To: Our Valued Customer

Subject: Implementation of the latest editions of GB/T 9364.2 and GB/T 9364.3 standards

Before	After
Plastic Bag/Carton Label		
Fuse Body/Cap

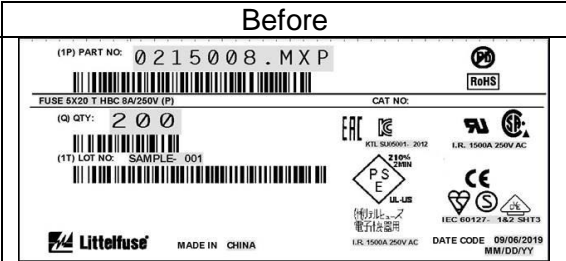
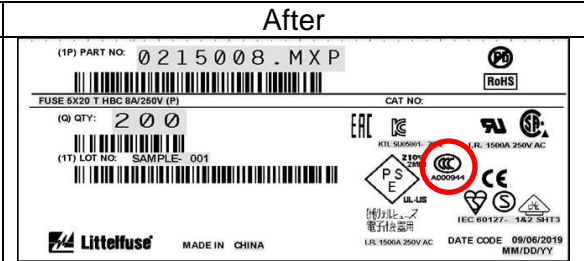
We are happy to inform you the majority of affected certificates have been updated, and the few remaining will be done by mid of Oct (see the chart below). There will be running changes to the actual products. Compliance with the new editions did not change the products; fit, form or function but did result in marking updates to some of our fuses. These marking updates include:

1. Addition of CCC certification mark or change of certification mark from CQC to CCC on plastic bag/carton label
2. Addition of CCC certification mark or change of certification mark from CQC to CCC on actual fuse body, and
